**The Woodlands Off-Site Sanitary Lift Station, Force Main & Gravity Sewer Line A (RFCSP)**

**Solicitation Number: CO-00682**

**ADDENDUM 3**

**November 15, 2023**

SHEET NO. **C3.1**

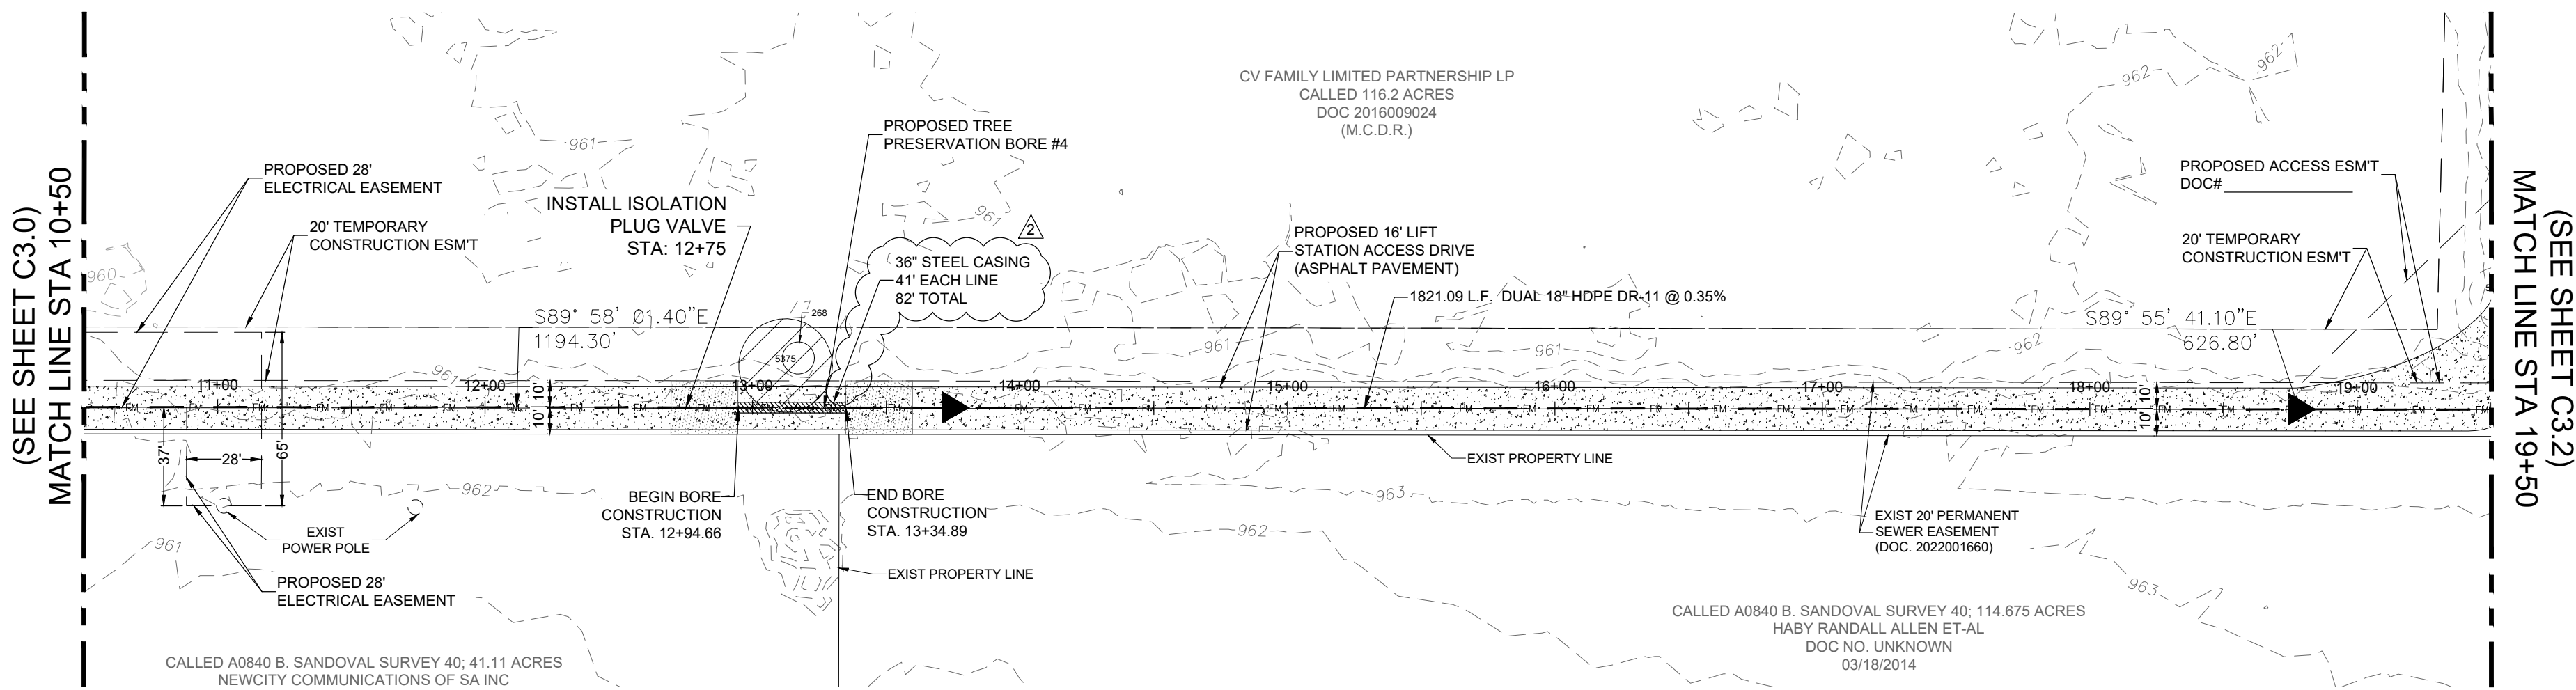
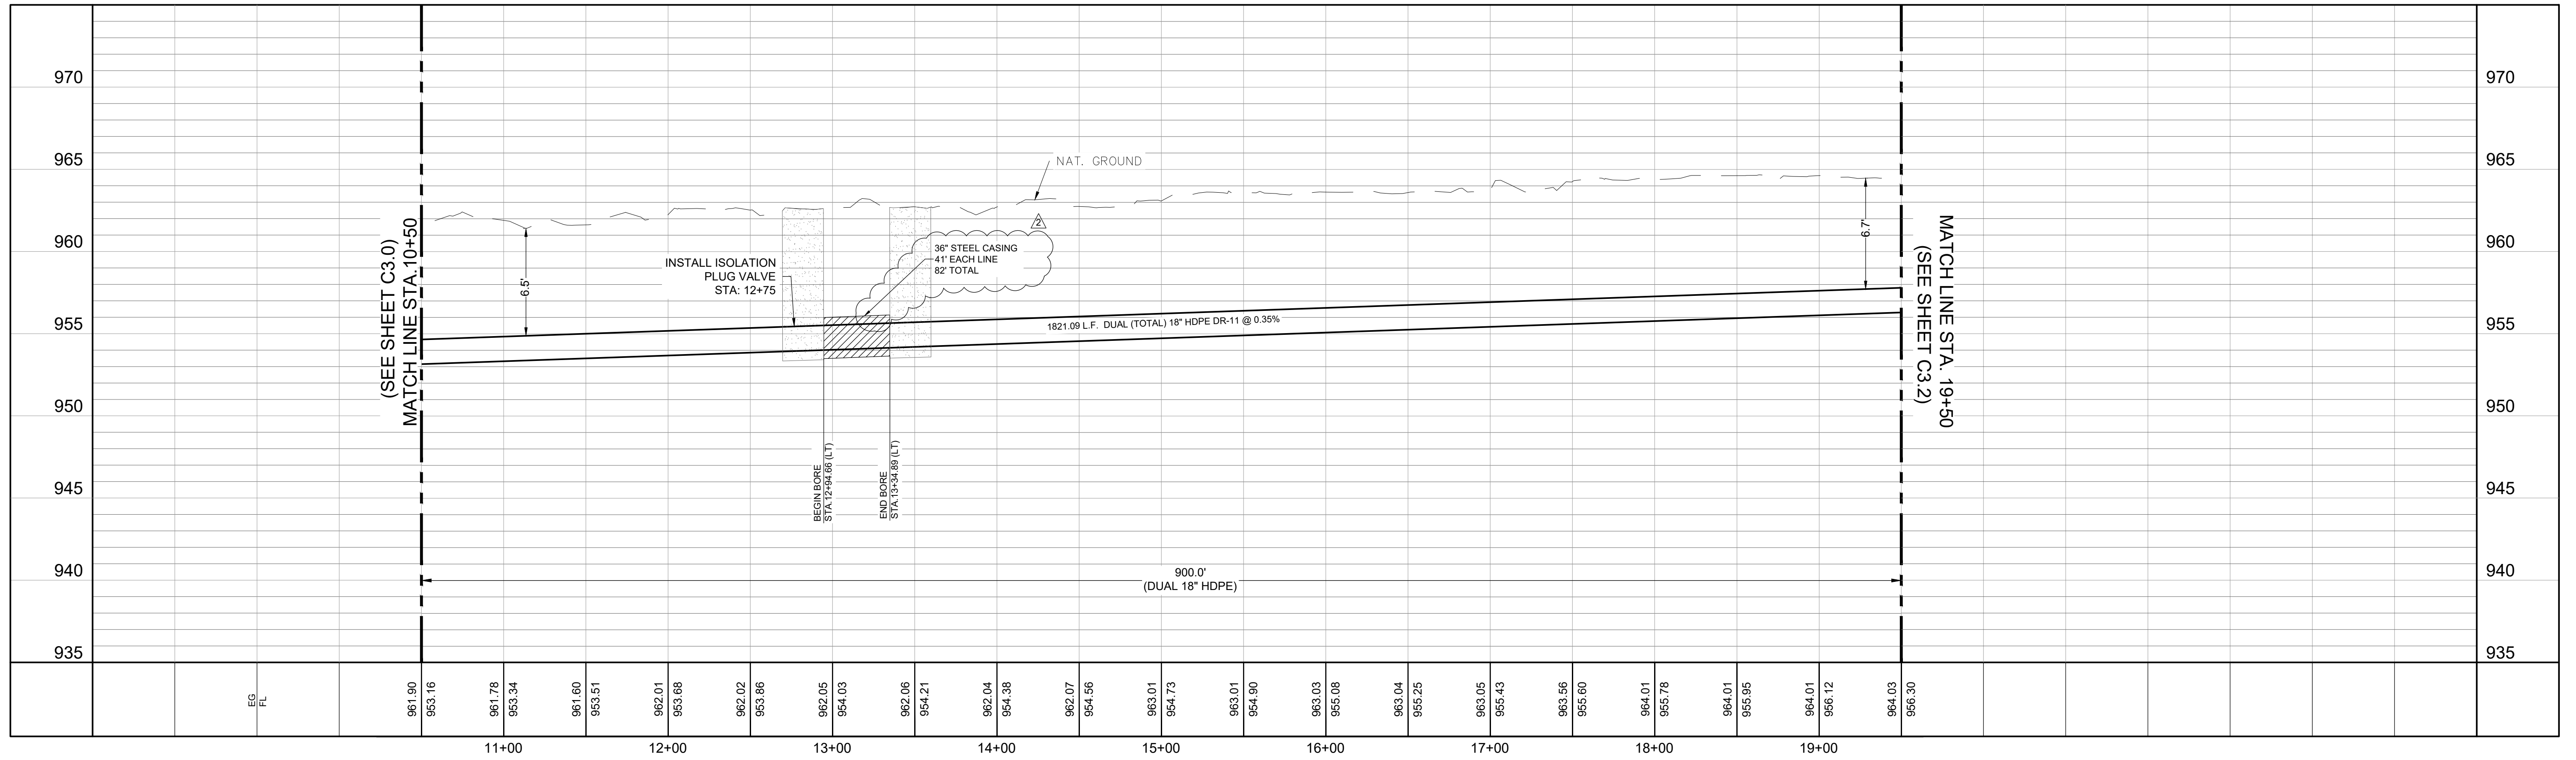
19. **Question:** Plan sheet C3.1 calls for 24" steel casing and plan sheet C3.2 calls for 30" steel casing, but the only bid item is for 36" steel casing. Is all of the casing for the force main bores to be 36"?

**Answer:** *The bid item is correct. All steel casing is to be 36" See Changes to the Plans #4. Sheets C3.1 and C3.2 have been revised accordingly.*

SHEET NO. **C3.6**

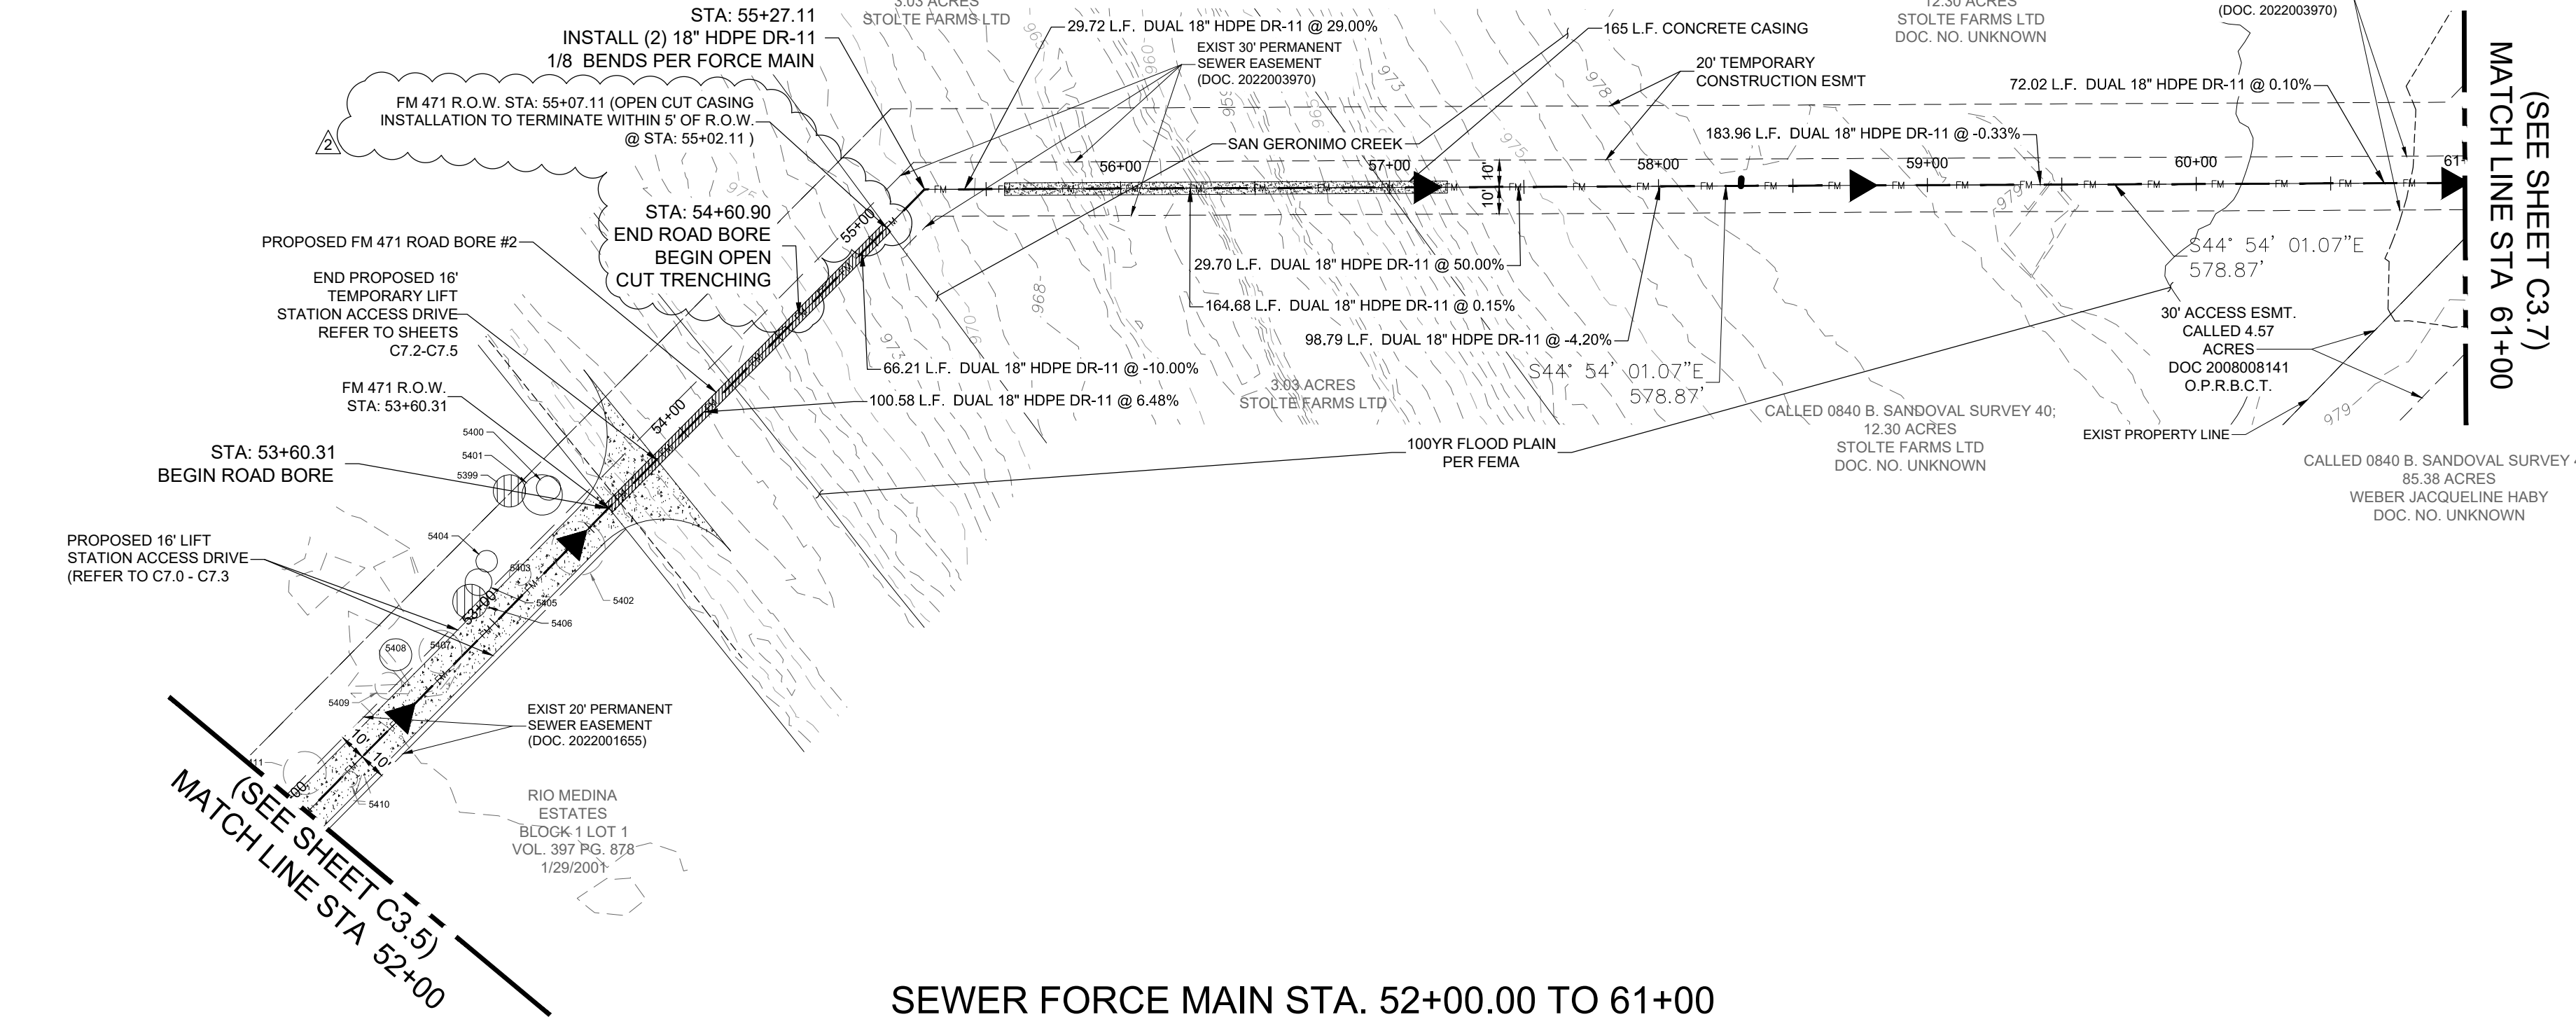
20. **Question:** On plan sheet C3.6 the plan and profile view calls for the road bore to end at station 54+60.90, but the profile shows the casing extending past station 55+00. Is the additional casing to be installed by open cut? And if so will a bid item be added for this?

**Answer:** *The road bore with steel casing is to begin at 53+60.31 and end at 54+60.90 with open cut trenching with steel casing from 54+60.90 to 55+07.11. See Changes to the Plans #5. Sheet C3.6 has been revised accordingly.*
